Item 3.**Development Application: 212-214 King Street, Newtown - D/2025/585**

File Number: D/2025/585

Summary Recommendation: This proposal is recommended for refusal.

Figure 10: Proposed floor plan (indoor dining seating area outlined in red)

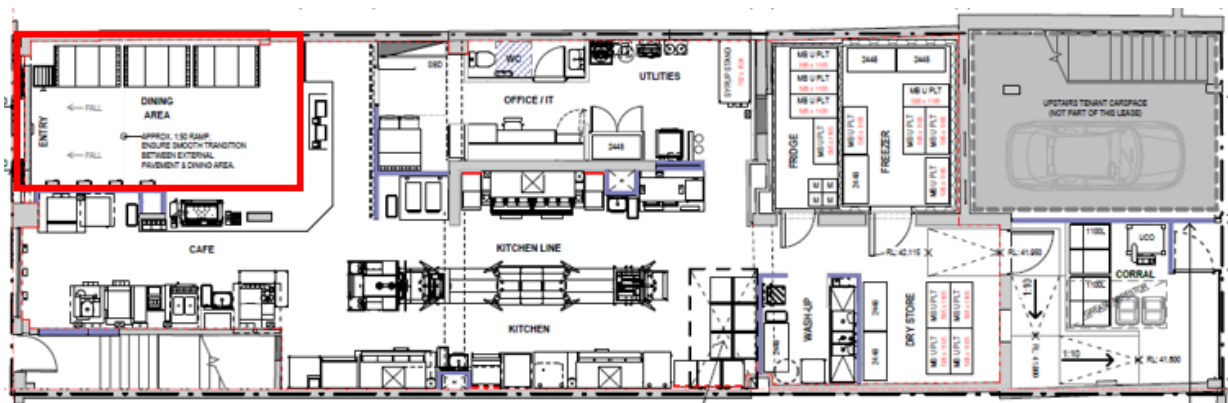
26. The proposed floor plan below shows an indoor dining area with booth seating for approximately 12 persons (outlined in red) and the rest of the floor area being a large kitchen and back of house (approximately 225 sqm or 90% of the premise's floor area). No toilets are provided for customers using the indoor dining area. Toilets are required under the NCC when there are more than 20 patrons. Only one toilet is provided for staff use which is located within the office beyond the café and kitchen. It is not clear if the toilet would be made available to delivery riders who will be regularly servicing the site.
27. The predominant service kitchen and food preparation areas compared to the dining area signifies that the majority of food and drink will be consumed away from the site. This issue cannot be addressed through the imposition of conditions or amendments to this application.
